N3381A-02A

S E R V I C E N O T E

Supersedes:
N3381A-02

N3381A PNA Microwave Network Analyzers

Figure 1: A3 Front Panel Interface Board Assy without the Bracket

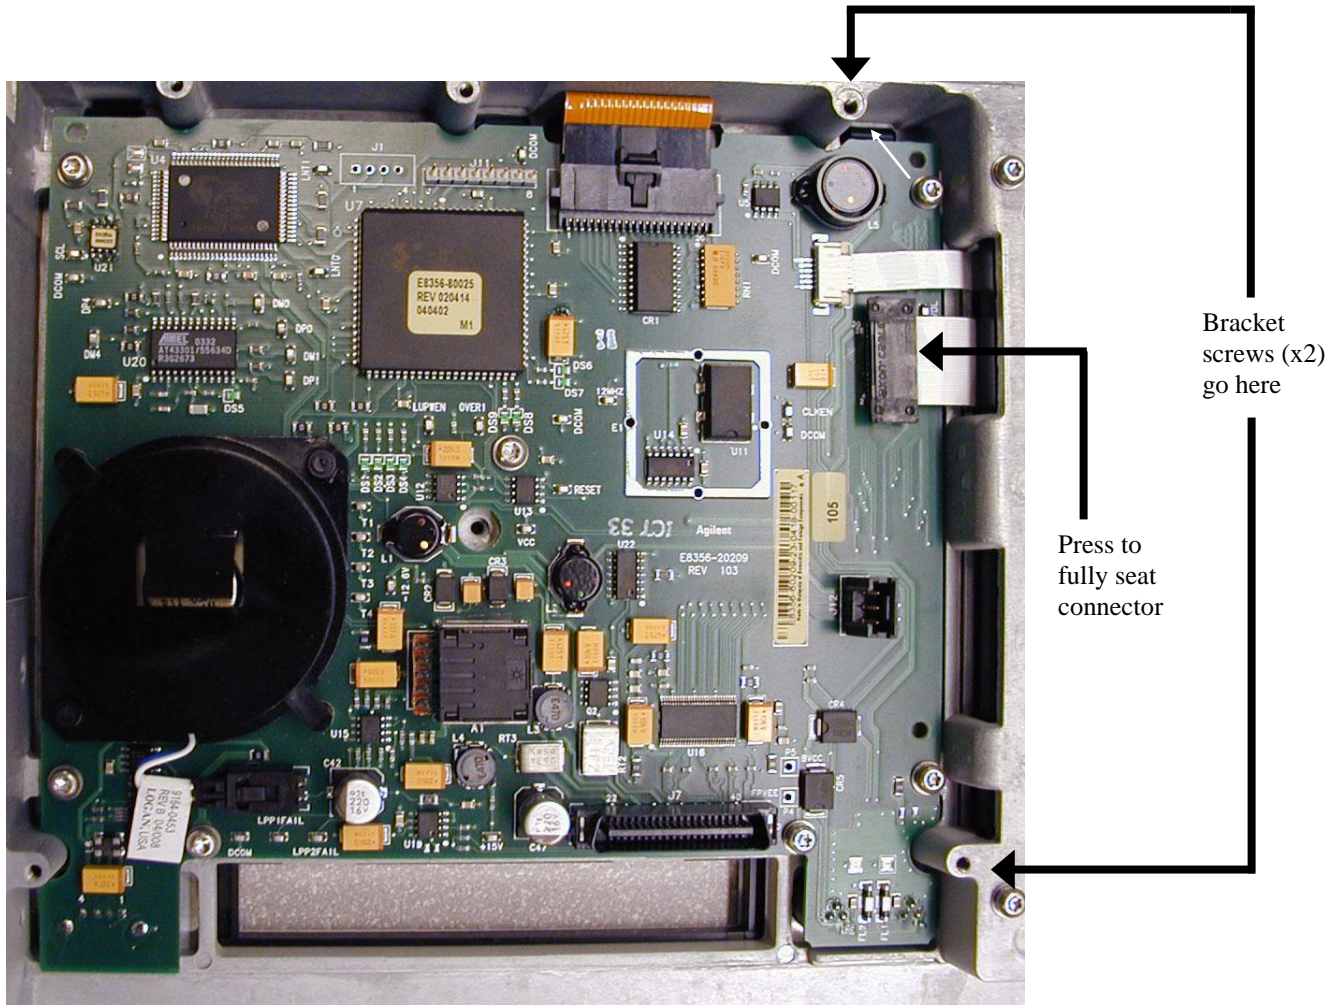
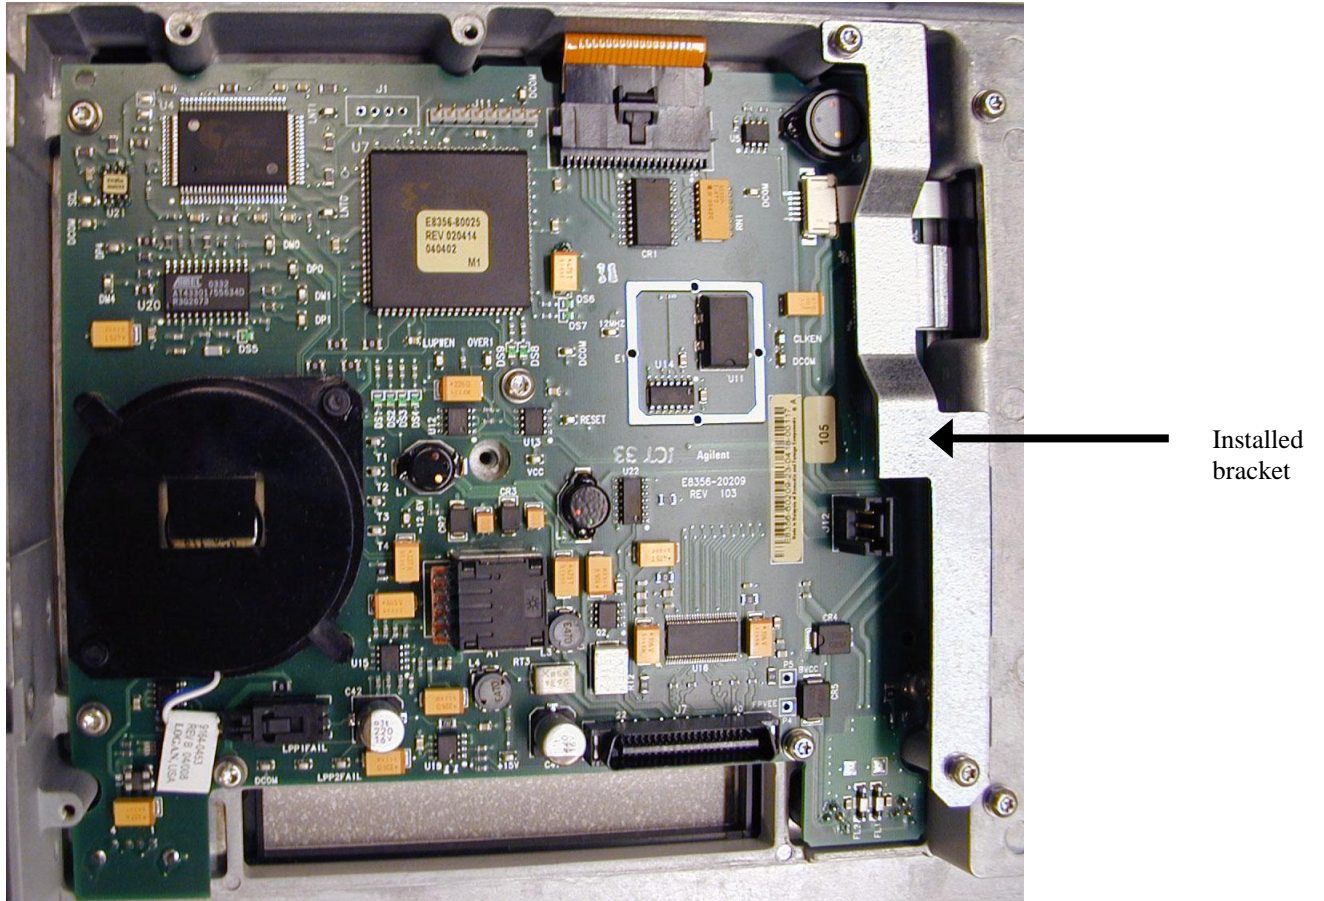
A connector of the ribbon cable (Agilent part number 8120-8409) that joins the front panel display to the front panel interface board can loosen, causing a display failure, unless a new bracket is installed. Because the failure rate has been very low, it is recommended that the bracket be installed only when there is an additional reason to remove the PNA front panel.

1. Refer to Figure 1 in this document:
 - Press down firmly on the ribbon cable's black connector.
 - Locate the two tapped holes for the bracket screws.
2. As shown in Figure 2 in this document, position the bracket so that its holes line-up with the two holes you located in the previous step.
3. Hand-start the two screws, and then torque both to 9 in-lbs.
4. Reinstall the PNA Front Panel by following the Service Guide instructions in the "Replacement Procedure." This is located on the same page as the "Removal Procedure" used previously in step 7.
